Re: Call for Review
Hillside Permit 4395; Tentative Parcel Map 061676;
Tree Removal Permit
720 S. San Rafael Ave.
Applicants: Chris & Lois Madison

RE Addendum Report to Report of June 21, 2004
720 South San Rafael Avenue

The following is an addendum to the report of June 21, 2004, as requested for you by Dennis Smith, Architect. The reason for the addendum is to respond to the "Review of Soils Report dated June 21, 2004 by Robert D. Cousineau _____", prepared by Sassan Geosciences, Inc., dated August 23, 2005

DIRECT SHEAR

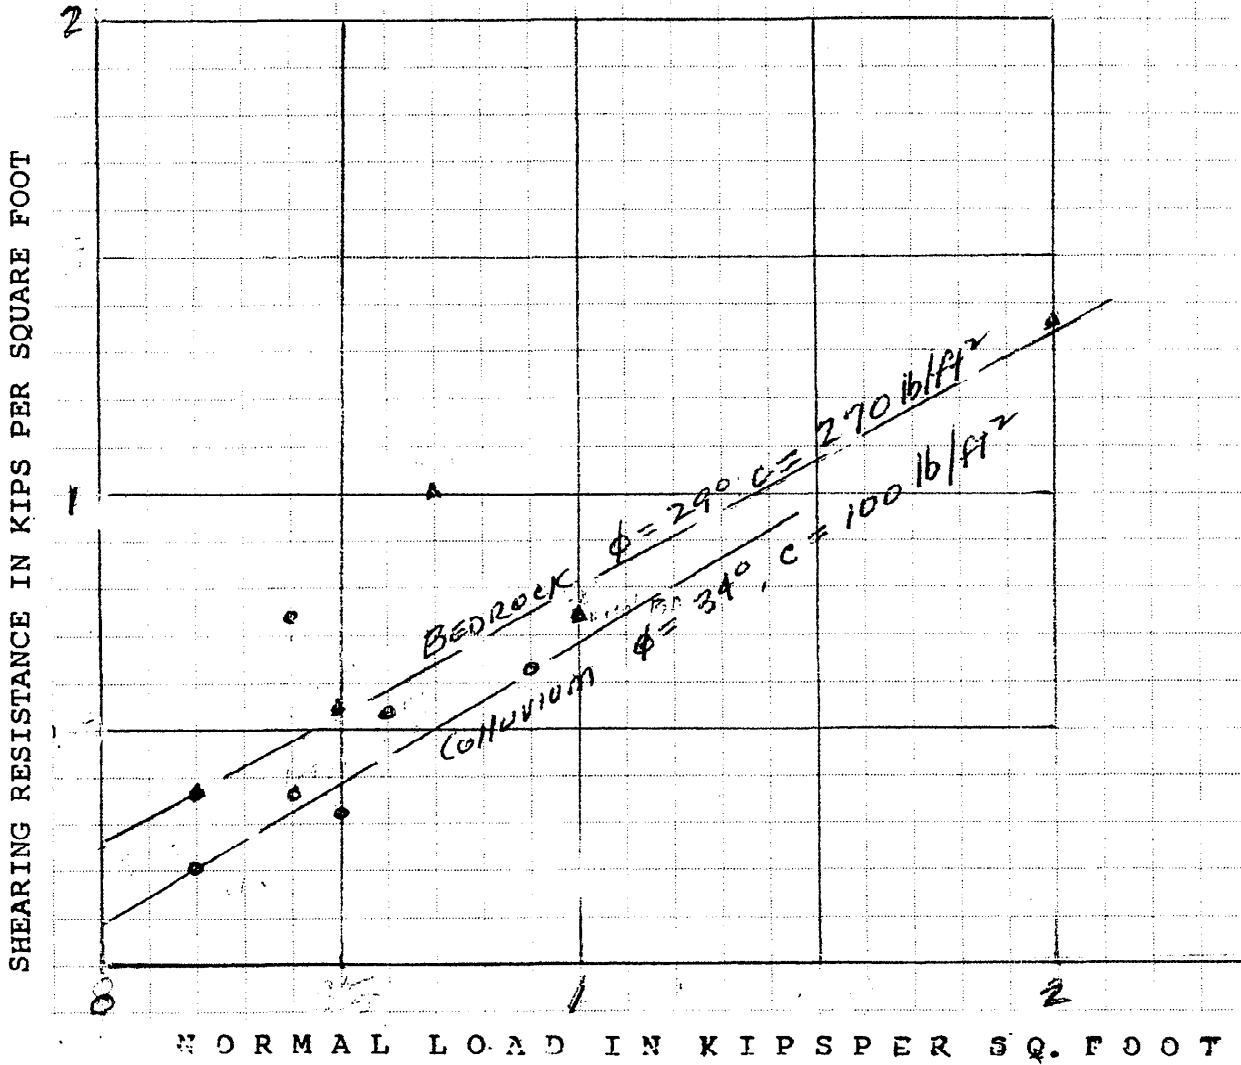
The direct shear tests do not classify the colluvium as silty sand but rather, silty clay. Their statement to the contrary is not correct.

SURFICIAL SLOPE STABILITY

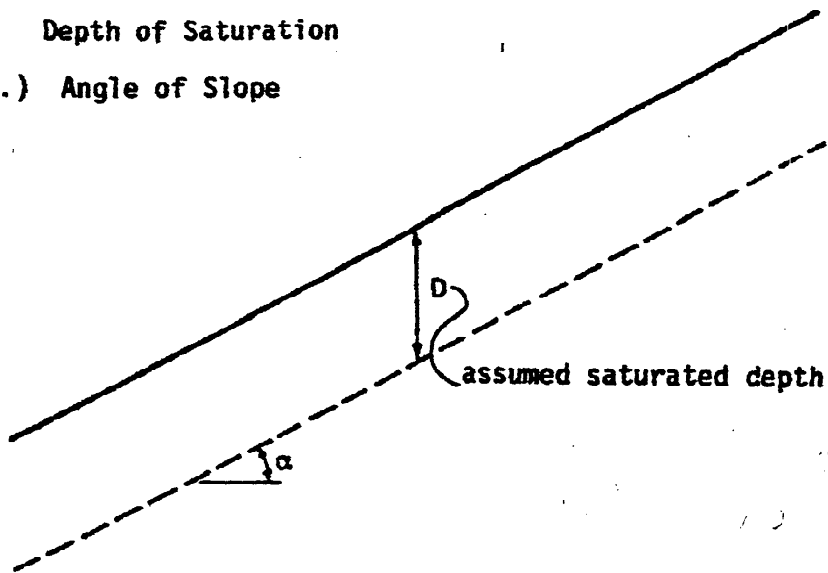
An analysis of surficial stability has been prepared and is shown on Plate H, attached. This indicates a factor of safety of 1.75 which exceeds the generally accepted value of 1.5

- $C = 100$ (psf) Cohesion
 $\phi = 34$ (deg.) Angle of Internal Friction
 $\gamma_d = 90$ (pcf) Dry Unit Weight - AVERAGE
 $\gamma_{sat} = 119$ (pcf) Saturated Unit Weight
 $\gamma_b = 56.6$ (pcf) Bouyant Unit Weight
 $D = 3$ (ft) Depth of Saturation
 $\alpha = 20$ (deg.) Angle of Slope

$$FS = \frac{C + \gamma_b \cos^2 \alpha \tan \phi}{\gamma_{sat} \cos \alpha \sin \alpha} = \frac{100 + 3 \times 56.6 \times \cos^2 20 \times \tan 34}{3 \times 119 \times \cos 20 \times \sin 20}$$

$$= \frac{100 + 115}{115} = 1.75$$

SLOPE STABILITY CALCULATIONS

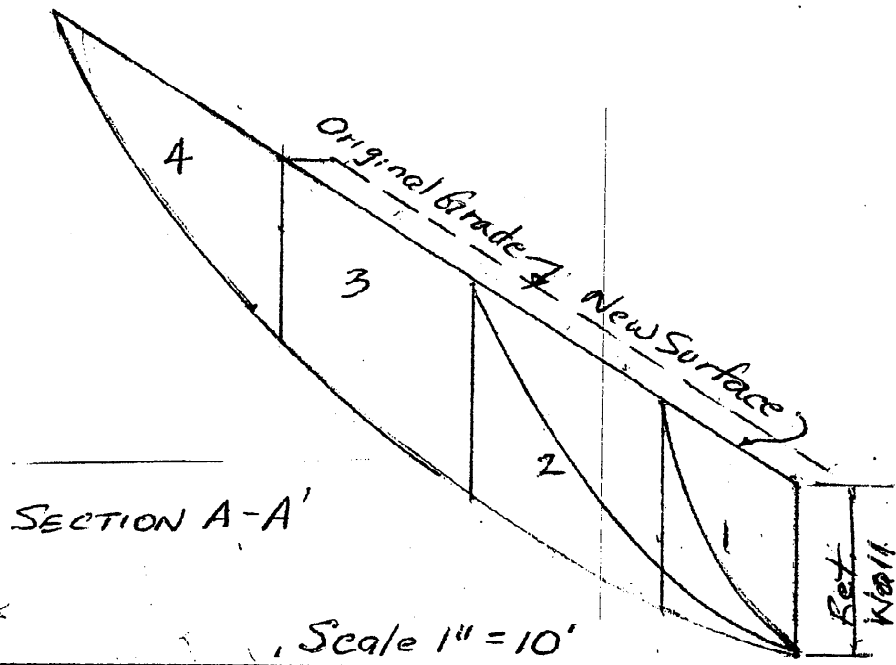
Shoring design is generally a factor addressed when final plans have been prepared. In any case, calculations shown on Plates I and J indicate that the proposed vertical cuts up to 9 feet would be stable. However, to preclude any requirements by governing agencies, it is recommended that cuts over 5 feet in height be sloped back on a 45 degree angle above 5 feet.

$$FS = \frac{\Sigma CL + \Sigma W \cos \alpha \tan \phi}{\Sigma W \sin \alpha} = \frac{13.78 + 15.55}{17.88} = 1.64$$
